**Service Information Number: SI-003**

**Subject: Gasket 82-50130-B verses 82-50130 Gasket.**

**Applicability: Where Gasket 82-50130 is required when mounting a dry air pump.**

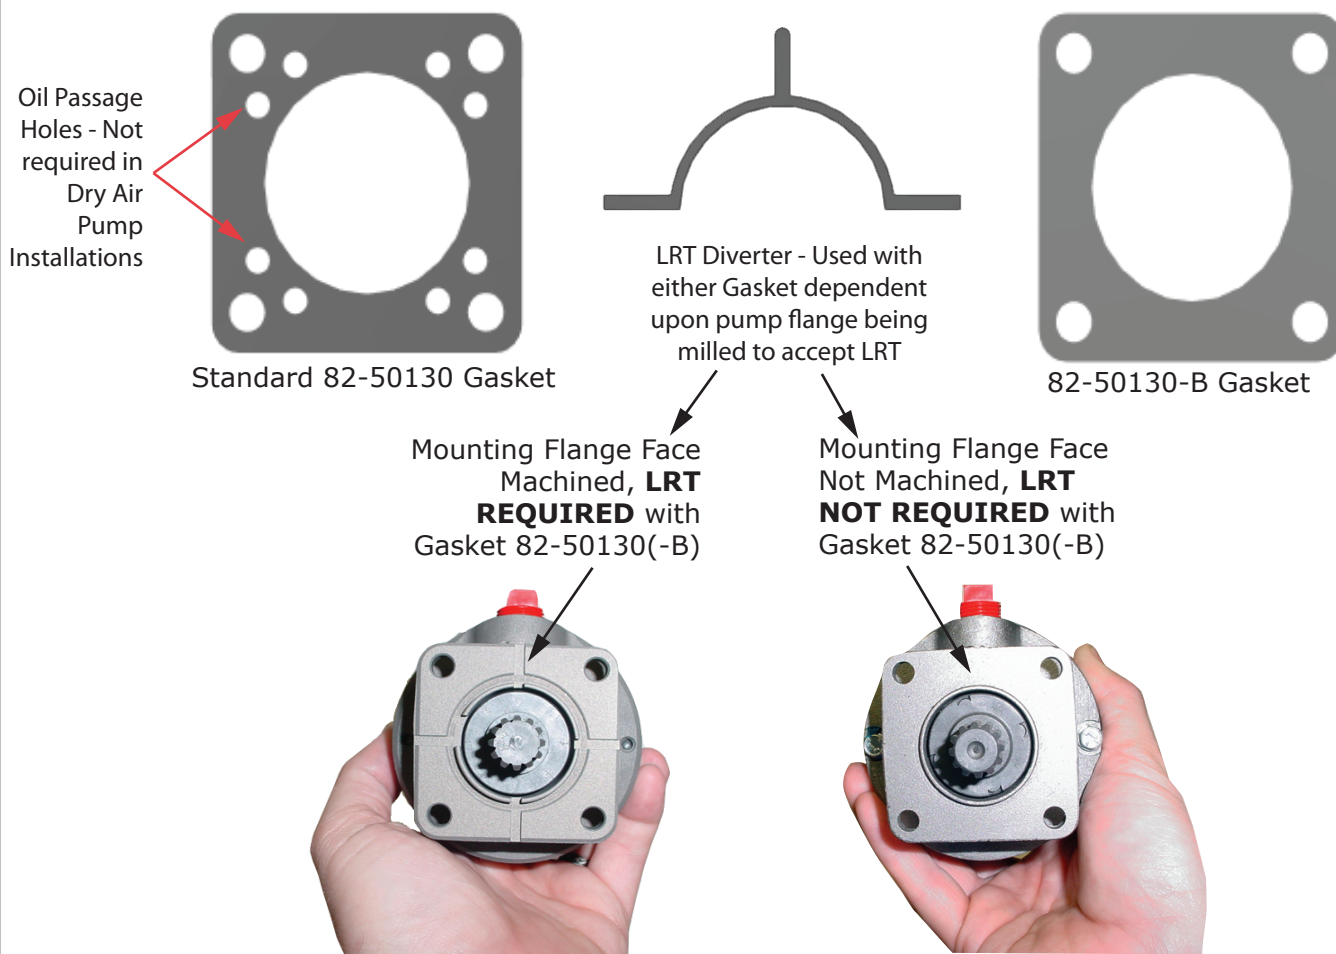
The 82-50130 gasket incorporates 8 small holes for accessories that require engine oil lubrication. The oil passage holes have been eliminated in the 82-50130-B mounting gasket. The LRT diverter is required on the Aero Accesories Dry Air Pumps that have channels milled into their mounting flange faces. Either the 82-50130 or 82-50130-B gaskets can be used with the LRT diverter, however the '-B' gasket is preferred due to its increased sealing capability.
